CALVERT CLIFFS NUCLEAR POWER PLANT

December 16, 2010

SUBJECT: Calvert Cliffs Nuclear Power Plant
Unit Nos. 1 & 2; Docket Nos. 50-317 & 50-318
Response to Request for Additional Information – American Society of
Mechanical Engineers Code Required Weld Inspections Relief Requests (TAC
Nos. ME4220 through ME4223)

**RESPONSE TO REQUEST FOR ADDITIONAL INFORMATION –
RELIEF REQUESTS ISI-24, 25, 26, AND 27**

(Sketch Resized for Relief Request)

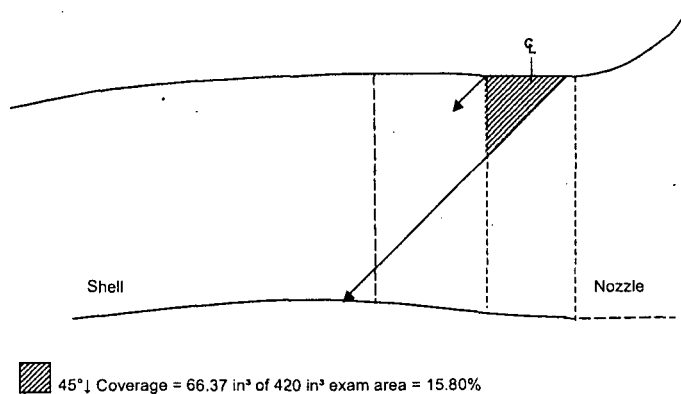
Coverage Dimensions							Beam Directions					
	Length	x	Width	x	Thickness	=	Result (Cub. In.)					
Exam Area:	51.85		6.3		4.5		1470.00	Toward Nozzle:	↑			
Weld Metal:	51.85		1.8		4.5		420.00	Away from Nozzle:	↓			
Base Metal:	51.85		4.5		4.5		1050.00	Clockwise:	←			
								Counter Clockwise:	→			
Weld Metal: Volume = 420.00 Cubic Inches							Base Metal: Volume = 1050.00 Cubic Inches					
Beam No.	Angle	Sketch	Coverage (Cub. In.)	Beam Total	Percent of 420.00		Beam No.	Angle	Sketch	Coverage (Cub. In.)	Beam Total	Percent of 1050.00
1	45°↑	1	419.16	419.16	99.80%		1 + 2	45°/60°↑↓	7	907.09	907.09	86.39%
2	45°↓	2	66.37	66.37	15.80%		3	45°←	8	525	525	50.00%
3	60°↑	3	418.44	418.44	99.63%		4	45°→	8	525	525	50.00%
4	60°↓	4	35.00	35.00	8.33%		5	60°←	8	525	525	50.00%
5	45°←	5	390.83	390.83	93.05%		6	60°→	8	525	525	50.00%
6	45°→	5	390.83	390.83	93.05%		7	0° WRV	8	525	525	50.00%
7	60°←	5	390.83	390.83	93.05%

(Sketch Resized for Relief Request)

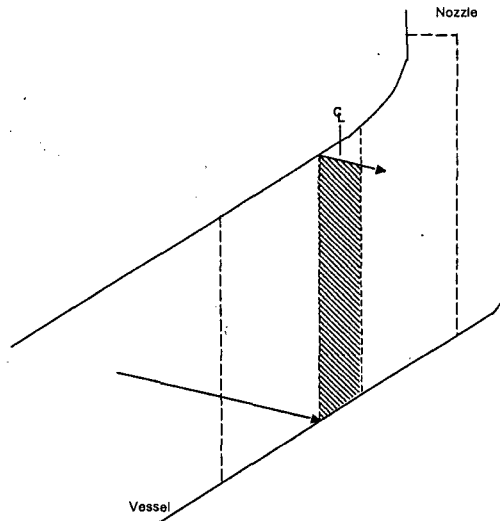
45° Coverage = 4.25 in² of 4.59 in² area = 92.59%

(Sketch Resized for Relief Request)

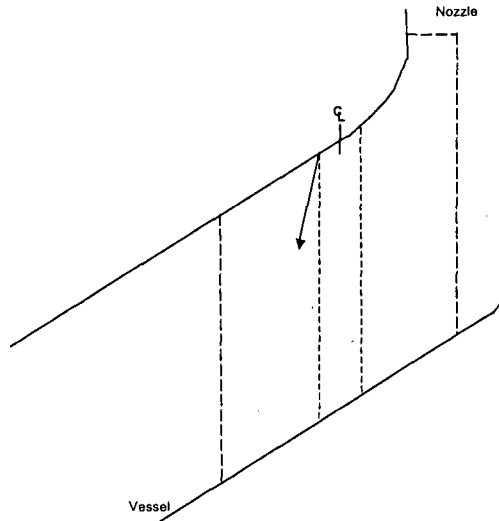
45° Coverage = 0 in² of 4.59 in² area = 0%

(Sketch Resized for Relief Request)

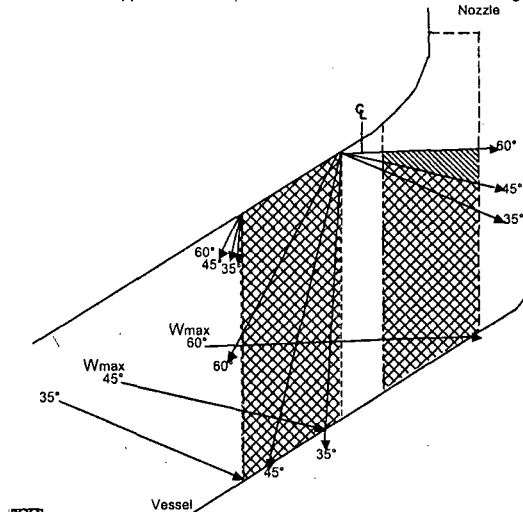
Note: At 180° the 45° & 60° exams were limited by the head to shell transition. A supplemental 35° was used to obtain additional coverage.

(Sketch Resized for Relief Request)

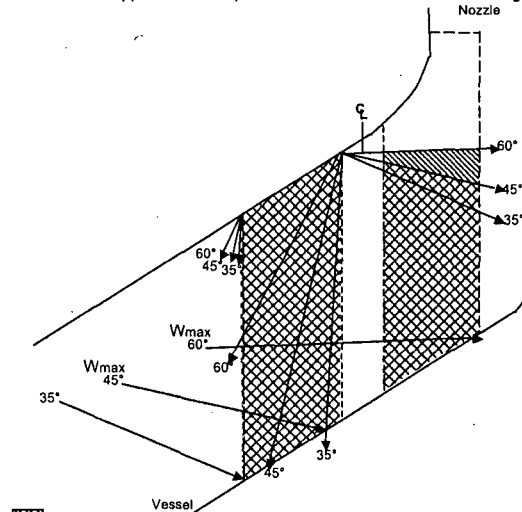
Note: At 180° the 45° & 60° exams were limited by the head to shell transition. A supplemental 35° was used to obtain additional coverage.

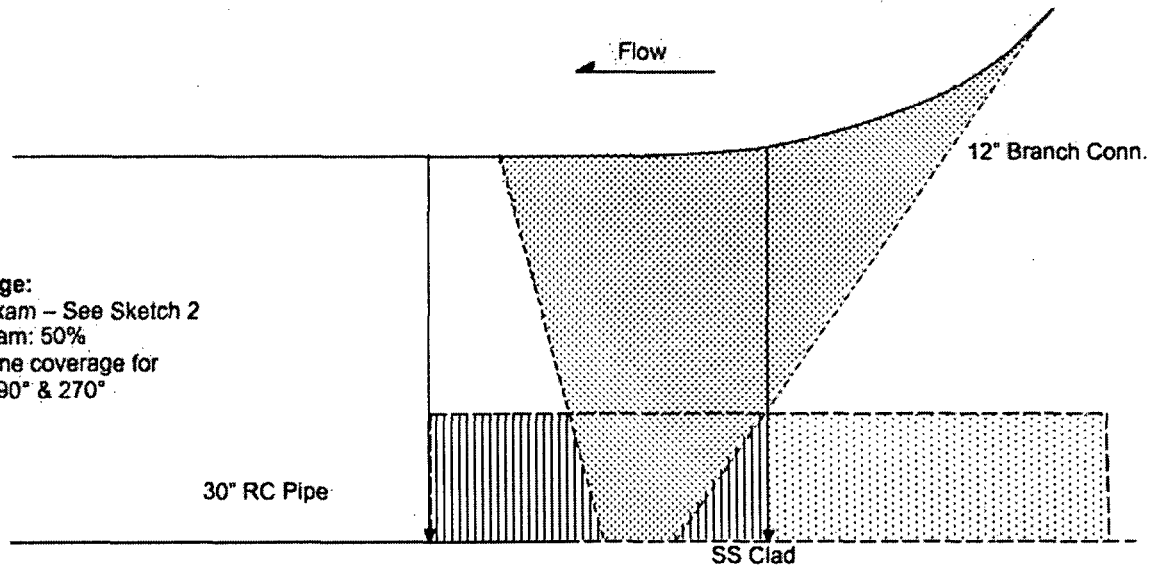
- Axial Exam – See Sketch 2
- Circ Exam: 50%

NOTE: Same coverage for quadrants 90° & 270°
